ADDENDUM NO. 4

RFQ CCC-056

**New Student Services Building
Compton Community College District**

tBP Project. No. 20987.00

drawing no.:
ET-8
drawing of

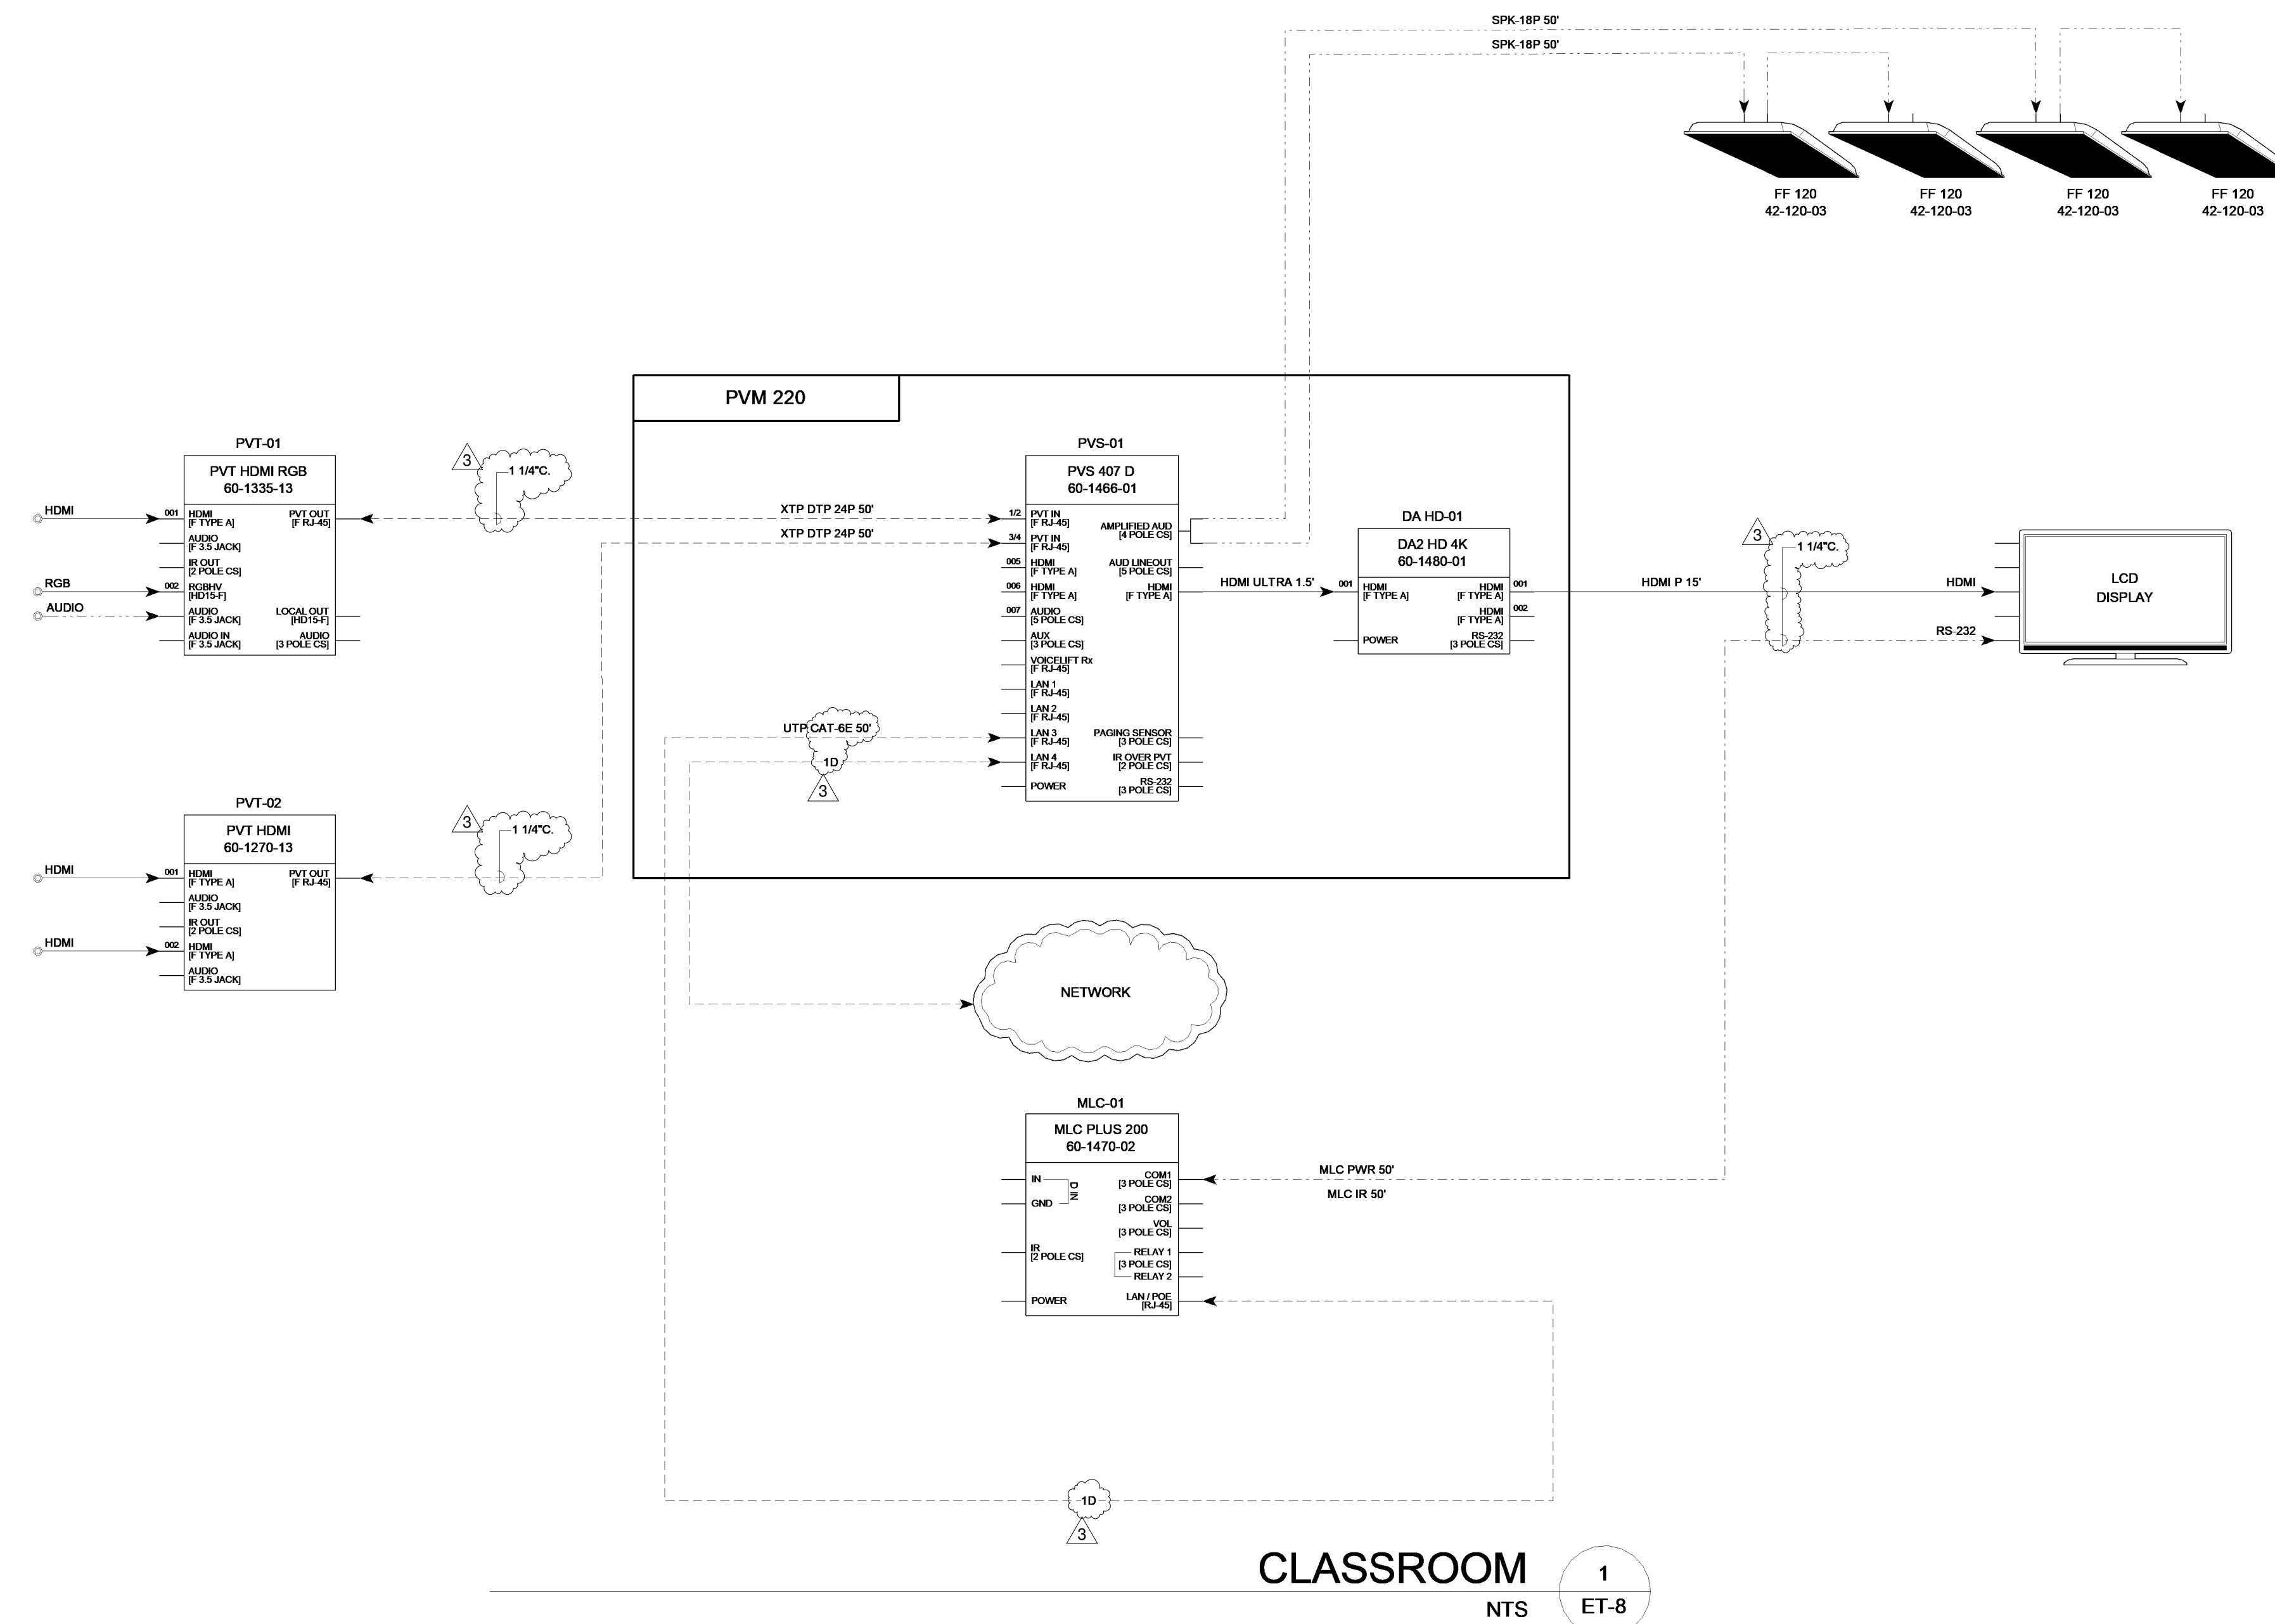
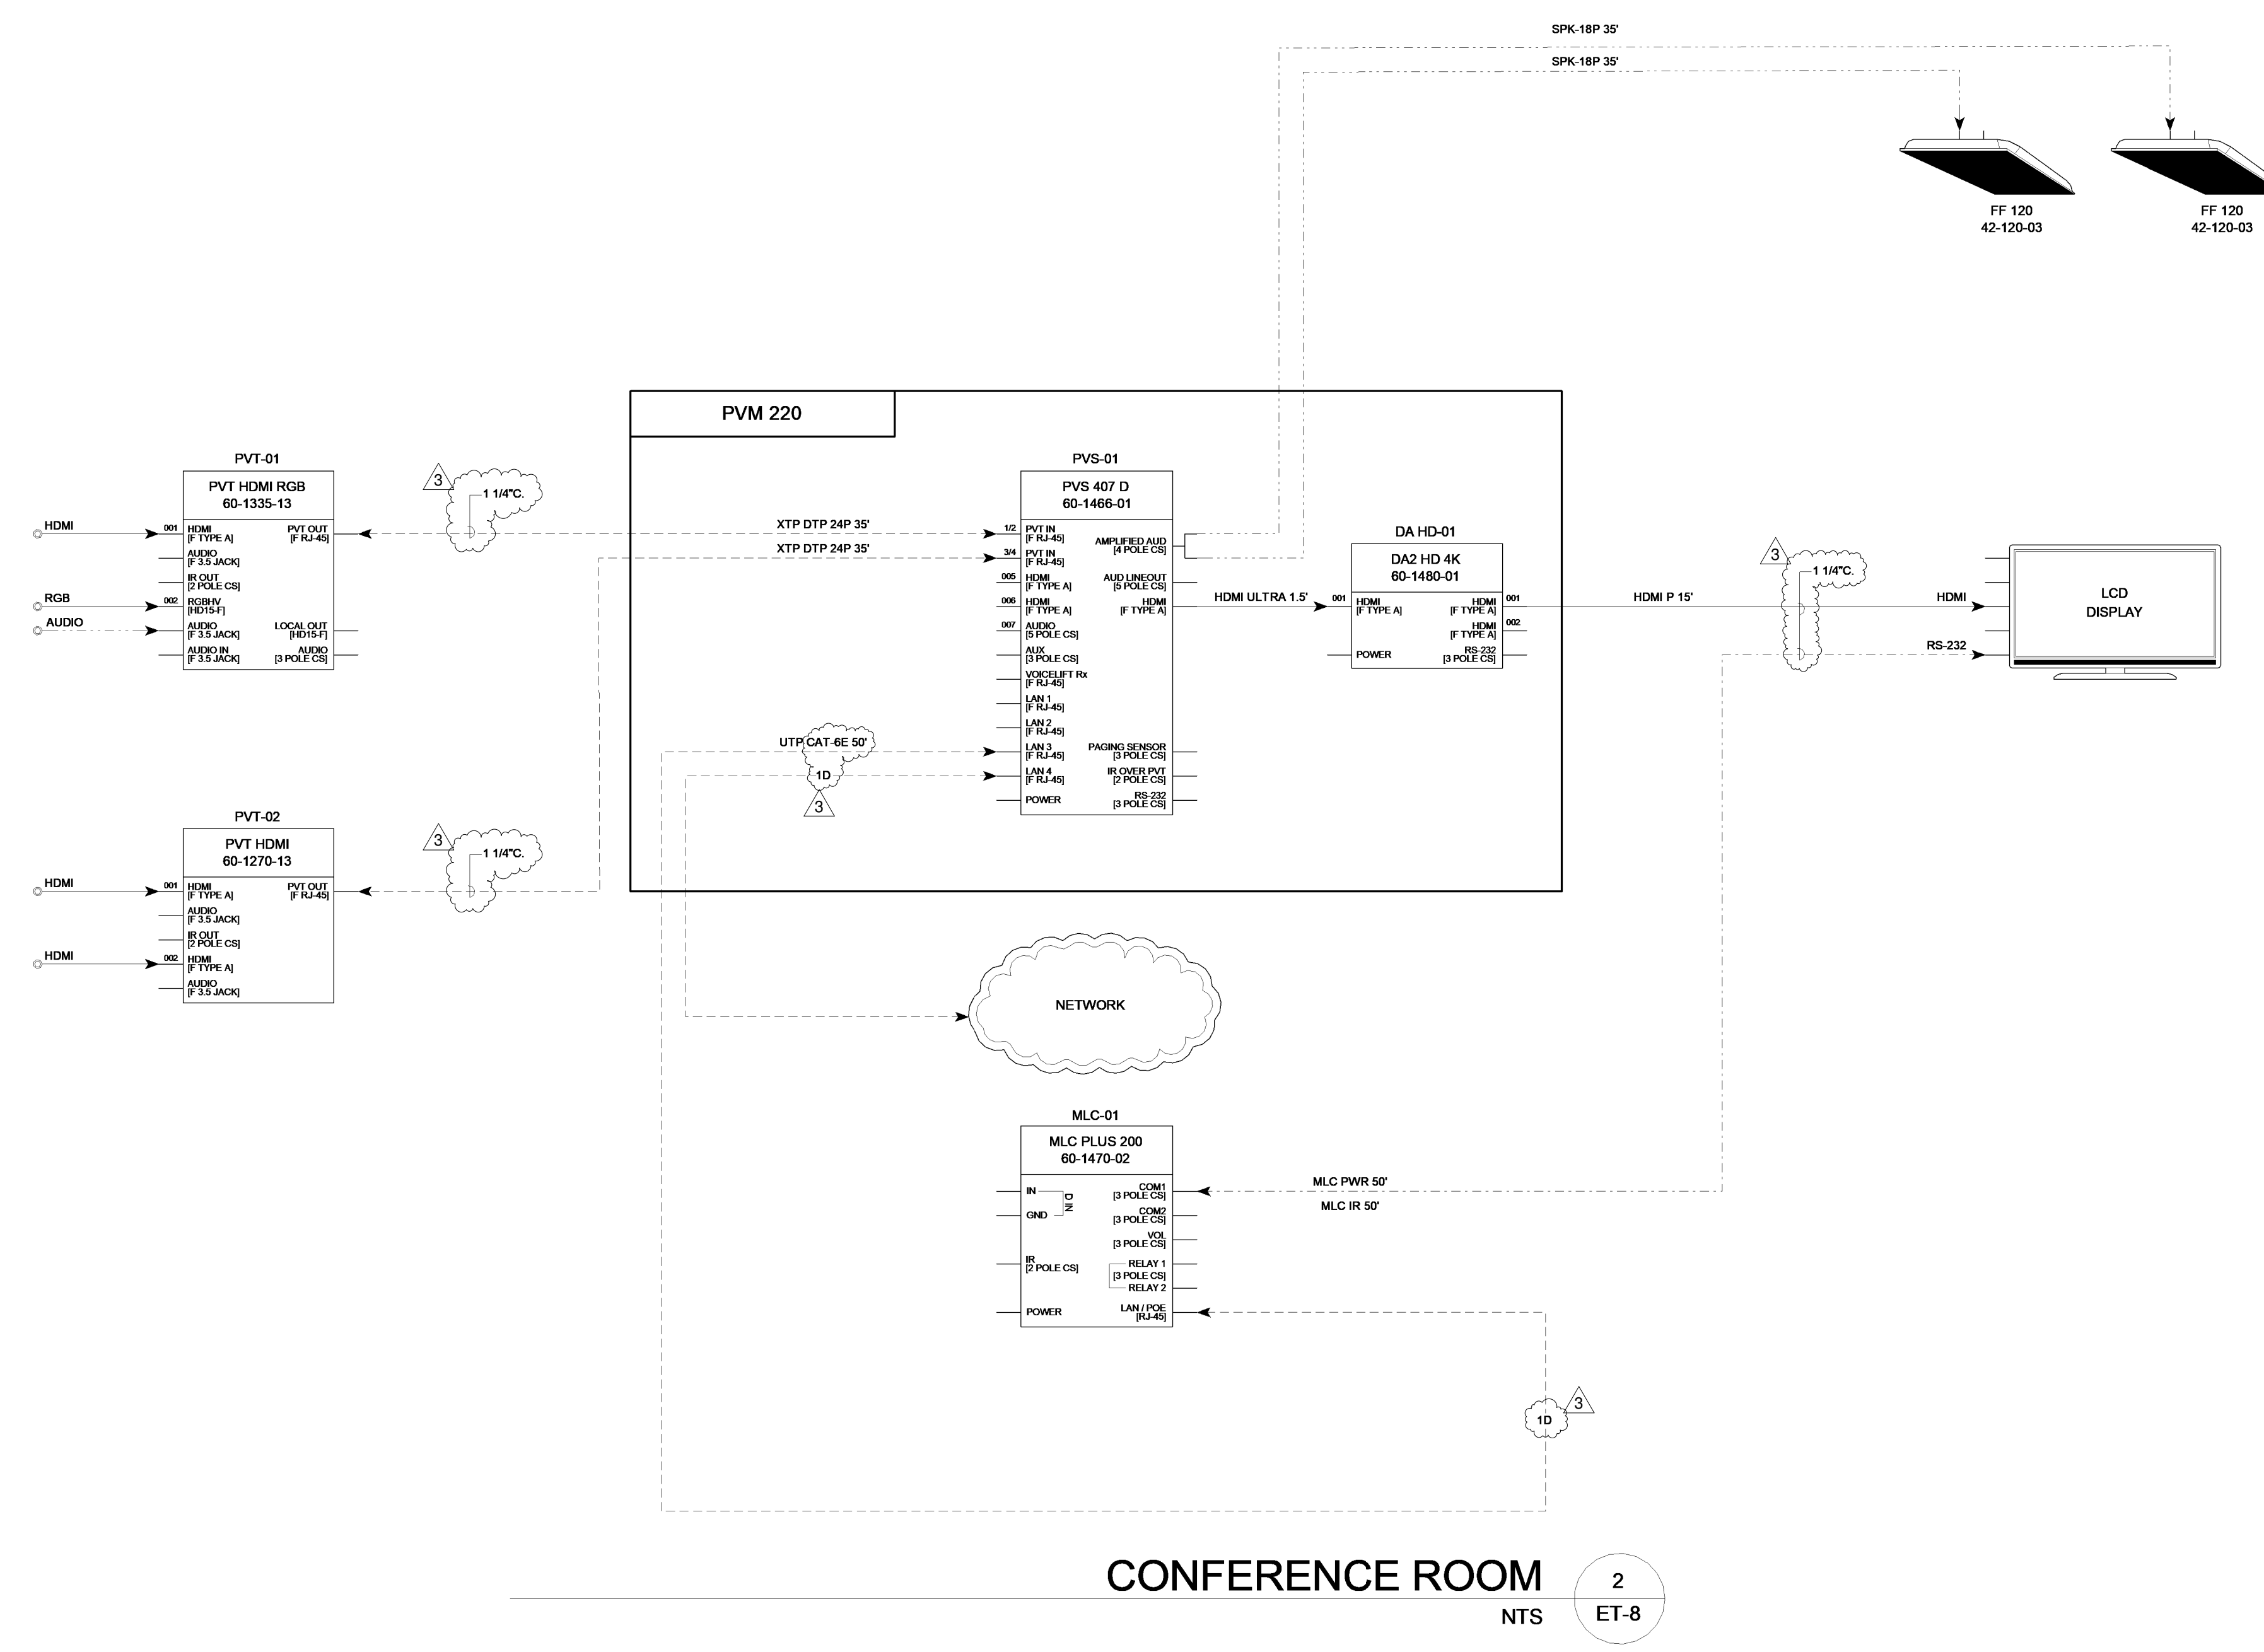
- b. Add Plan Notes.
38. Revised SHEET ET-8 AV WIRING DIAGRAMS
 - a. Revise AV Wiring diagrams to include conduit requirements
 - b. Add AV Performance Notes.
